ANN ARBOR HISTORIC DISTRICT COMMISSION

Staff Report

ADDRESS: 210 South Fifth Avenue, Application Number HDC12-235

APPLICATION: The applicant seeks after-the-fact HDC approval to replace the front façade with a new design featuring larger windows and horizontal wood siding. In addition, conceptual approval for future signage as shown on the drawings is also requested.

2 Front Elevation - Proposed
A-3.1 Scale: 1/4" = 1'-0"

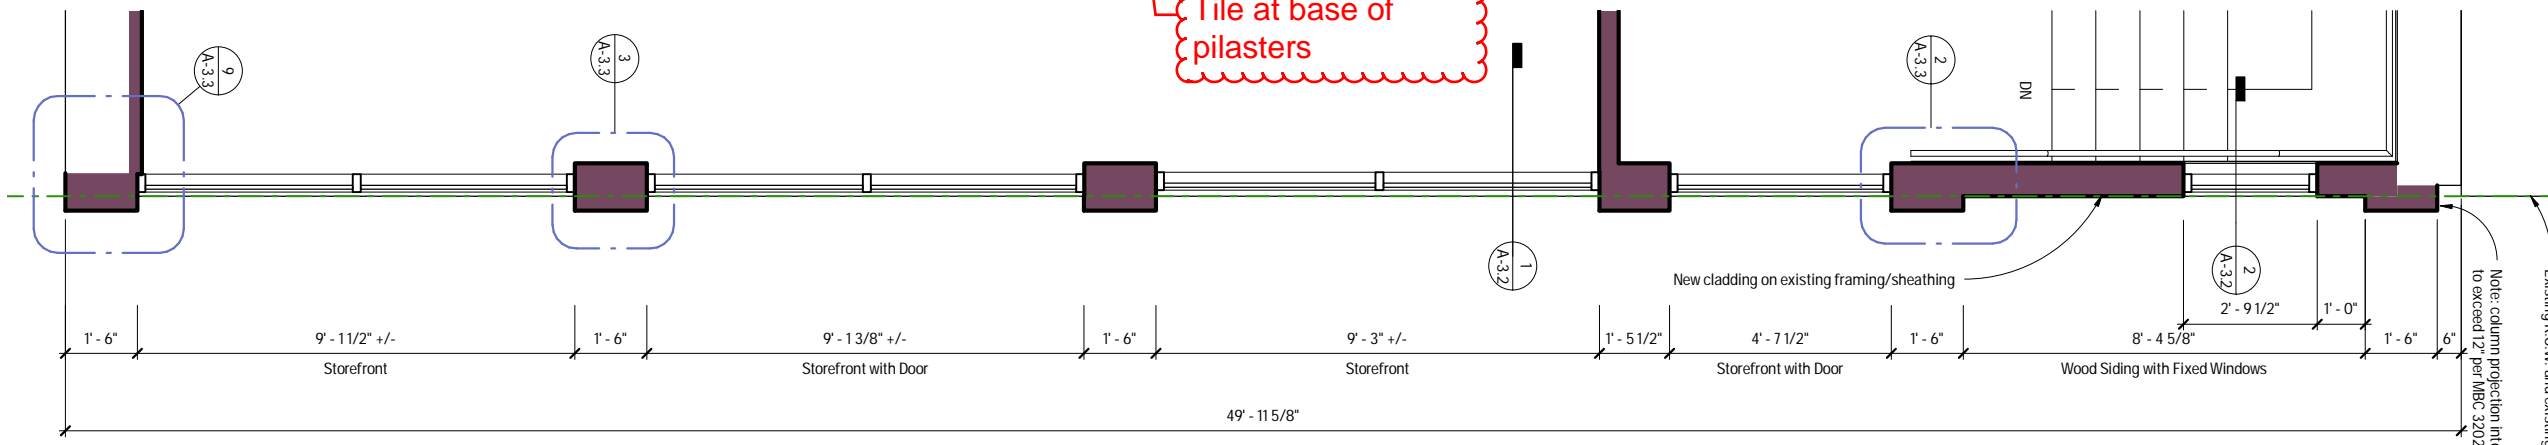
1. The proposed design and materials of the front façade on this non-contributing building are compatible with the surrounding historic district, and an improvement over the most recent façade. The streamlined, metal-clad 1999 design had been painted over and altered by an awkward sign and unbalanced double doors. The proposed redesign features horizontal tongue and groove cedar siding, vertical columns with EFIS plaster, a large amount of glazing, balanced bays, and two single entry doors.

2. The proposed conceptual signage consists of two first-floor awnings and a blade sign. The signage is balanced and tasteful. Staff requests conceptual approval of the signage conditioned on the applicant's obtaining a future staff approval for the final design, dimensions, and materials before sign permits may be issued.

I move that the Commission issue a certificate of appropriateness for 210 South Fifth Avenue, a contributing structure in the Main Street Historic District, for the application to reconstruct the front façade, provided the following condition is met: before sign permits are issued, a staff approval must be obtained for signage and awnings that are in keeping with the concept shown on this application. The work as conditioned is generally compatible in exterior design, arrangement, texture, material and relationship to the rest of the building and the surrounding area and meets *The Secretary of the Interior's Standards for Rehabilitation and Guidelines for Rehabilitating Historic Buildings*, in particular standard 9 and the guidelines for storefronts.
